## Well Abandonment Completion Report

**Notice of Intent to  
Abandon a Well**

**NOTICE OF INTENTION TO DRILL MONITOR/PIEZOMETER WELL**

**Re: Request for Variance for Two Monitor Wells  
Well Registry #55-586531 and 55-586532  
T13S, R13E, Section 35 BDA**

Provide a well construction diagram showing all existing well construction features listed in Section 5 and the proposed abandonment specifications listed in Section 6.

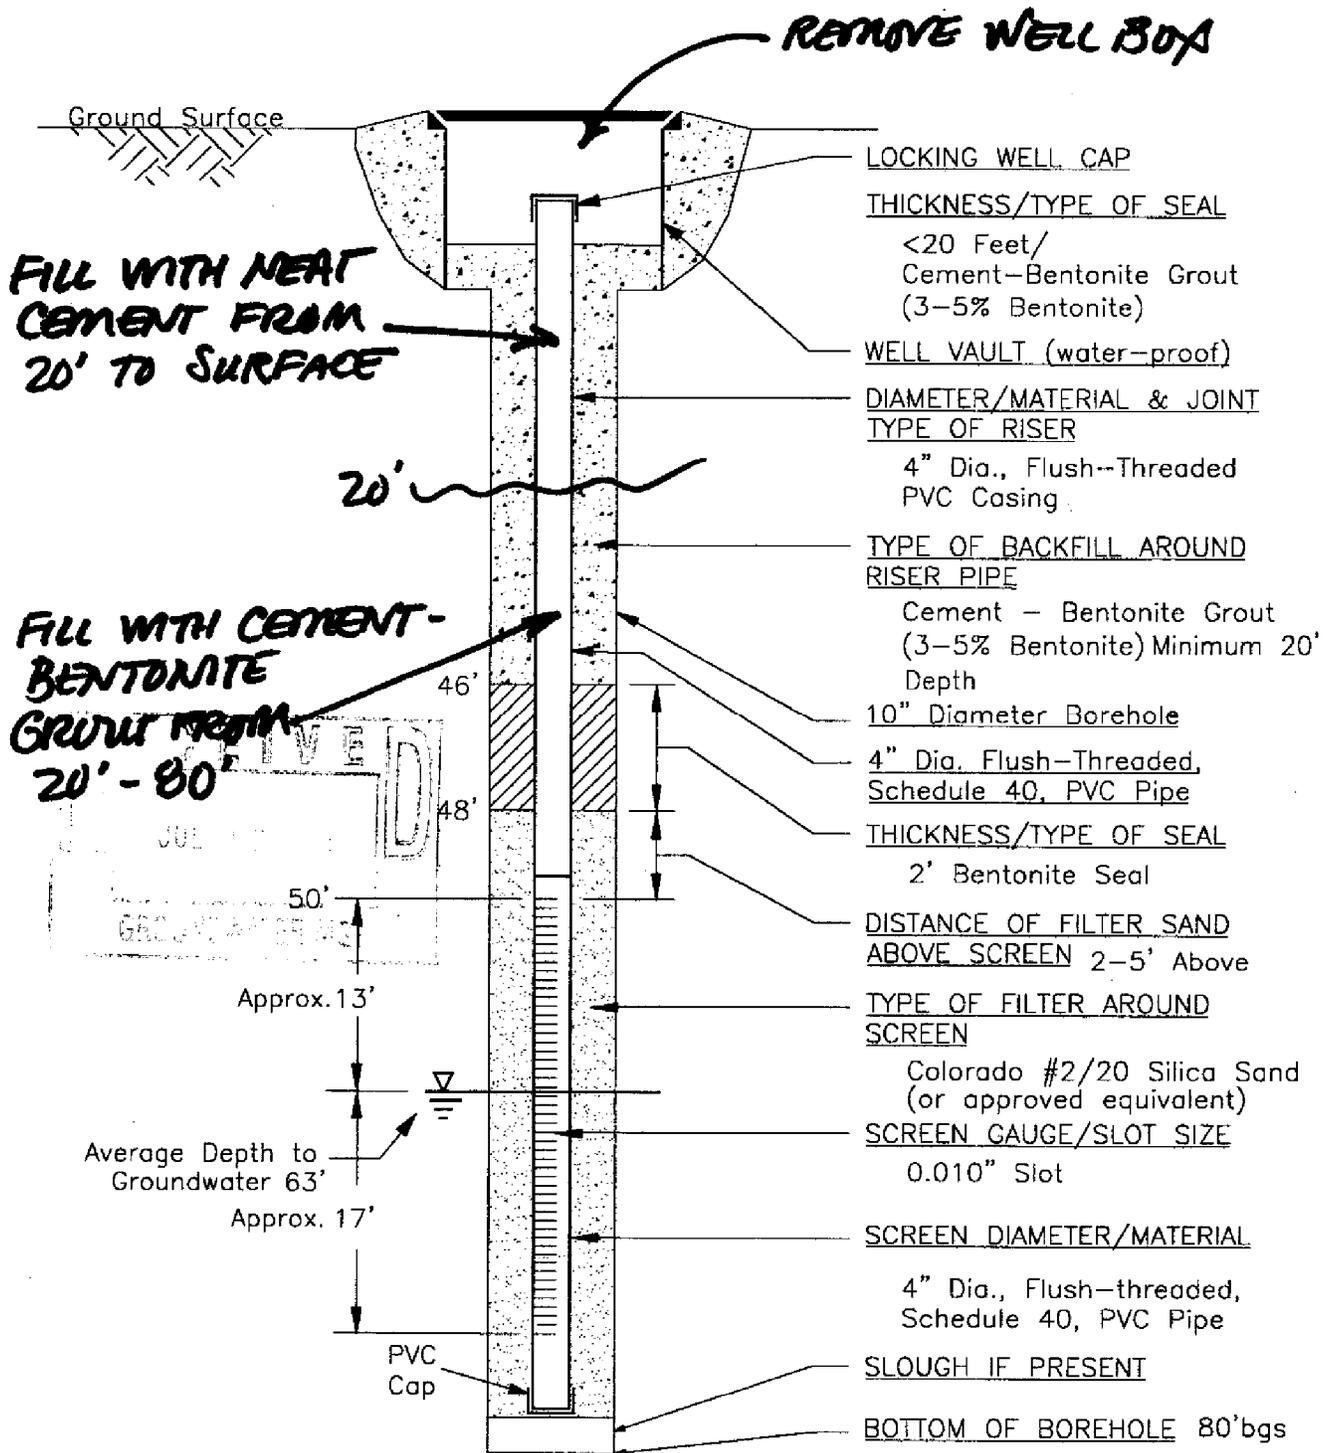
**SECTION 6. PROPOSED WELL ABANDONMENT DESIGN** (attach additional page if needed)

Casing Treatment					Sealing or Fill Material															
DEPTH FROM SURFACE		TREATMENT TYPE (T)				DEPTH FROM SURFACE		MATERIAL TYPE (T)								MIXING RATIO by (check one) <input checked="" type="checkbox"/> Weight <input type="checkbox"/> Volume	ESTIMATE VOLUME OF MATERIAL (cubic feet)			
FROM (feet)	TO (feet)	SONAR-JET	BRUSH OR SCRAPE	MILLS KNIFE	CASING REMOVAL (explain in Remarks)	IF OTHER TYPE, DESCRIBE OR IF CASING IS TO BE PERFORATED, DESCRIBE SPACING AND SIZE OF PERFORATIONS TO BE ADDED	FROM (feet)	TO (feet)	NEAT CEMENT	CONCRETE	SAND-CEMENT GROUT	CEMENT-BENTONITE GROUT	SAND-BENTONITE GROUT	HIGH SOLIDS BENTONITE	GROUT			CHIPS	PELLETS	SAND
						None	0	20	X											1.7
							20	80				X								5.2

20. Include detailed construction diagram showing expected water depth in feet below land surface, and details of vault, if specified.

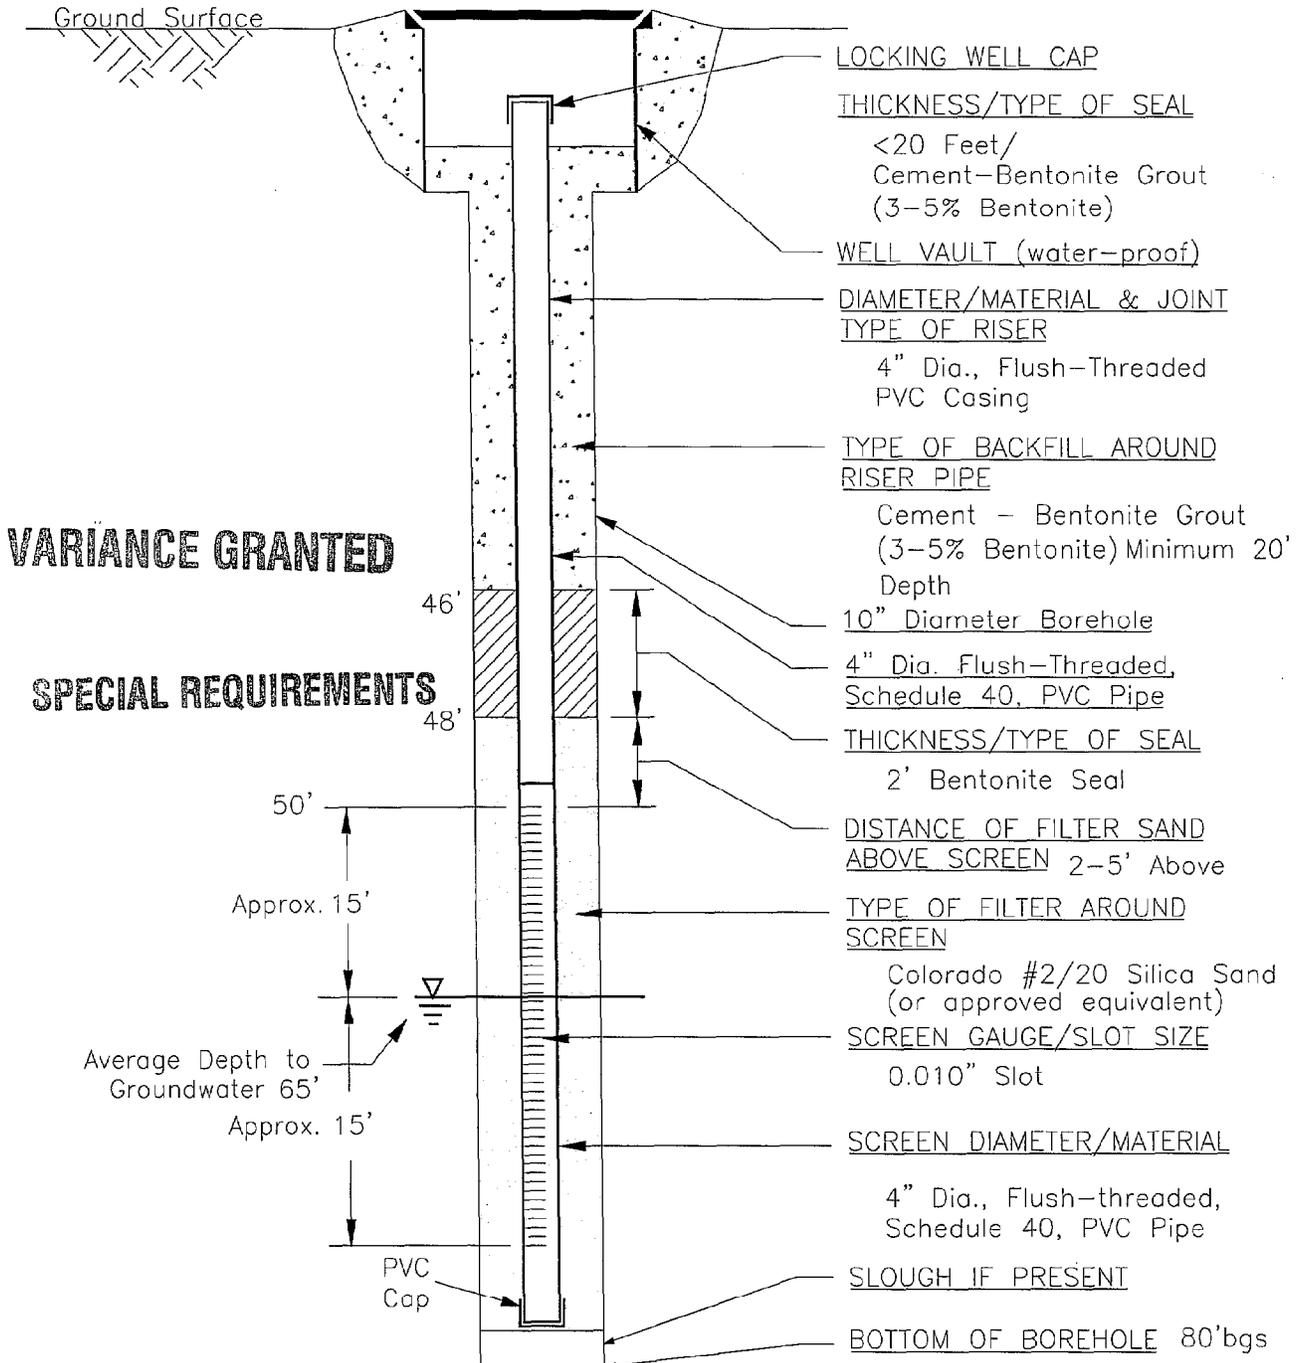
**15. Proposed method of abandonment of well after project is completed:** Remove upper 20' of casing  
and backfill with grout, pursuant to R12-15-816.

- a) Drilling method (mud rotary, hollow-stem auger, etc.) Hollow-stem auger
b) Borehole diameters: 10 inches from 0 feet to 80 feet.
c) Casing materials (PVC, steel, hollow-stem auger, etc.) material Sch. 40 PVC diameter 4 inches from 0 feet to 50 feet.
d) Method of sealing at reductions N/A
e) Annular seal materials (cement, grout, etc.); method of placement (tremied, circulated): material cement/bent. grout method tremie from 0 feet to 46 feet.
f) Filter packs (state material): material 10x20 silica sand from 48 feet to 80 feet.
g) Perforations or screen specifications: Type 0.010" slot Sch. 40 PVC from 50 feet to 80 feet.
h) Method of well development (bail, air lift, surge) surge, bail, pump
i) Will surface or conductor casing extend above grade?: Yes No x

- Thermoplastic inner casing (riser) with a watertight cap may be used in lieu of the required 20-foot steel surface casing [R12-15-811(B)(1)].

- The PVC inner casings (risers) shall comply with ASTM Standard Guide D5092, Section 6.5.
- The wells shall be constructed per the "Variance Granted" Notice of Intention to Drill.
- The wells shall be abandoned (decommissioned) per A.A.C. R12-15-816.
